2018 Basin Boundary Modifications - Final

Basin(s): 4-004.02 SANTA CLARA RIVER VALLEY - OXNARD; 4-004.03 SANTA CLARA RIVER VALLEY - MOUND; 4-004.04 SANTA CLARA RIVER VALLEY - SANTA PAULA

Agency: Mound Basin Groundwater Sustainability Agency

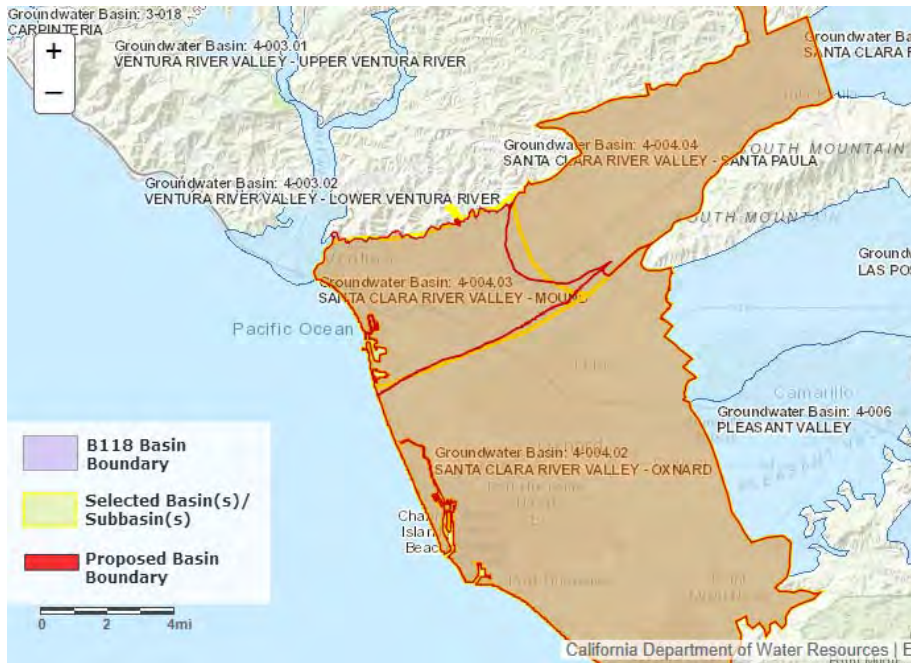
Description: Four proposed modifications: three jurisdictional internal and one scientific external.

DWR Final Decision: Approve

Basis for Decision: The basin boundary modification revises and aligns the shared boundary between the Mound and Santa Paula subbasins to align with the Santa Paula adjudicated boundary. The modification also revises the shared boundary between the Oxnard, Mound, and Santa Paula subbasins to align with the Fox Canyon Groundwater Management Agency's boundary and the Santa Paula adjudication boundary, where applicable. The scientific modification along the northern boundary of the Mound subbasin follows mapped alluvial units using a more detailed, 1:24,000 scale, qualified map. Two letters of support are associated with the request. The requesting agency supplies sufficient information to support the scientific rationale for modification and meets regulatory requirements.
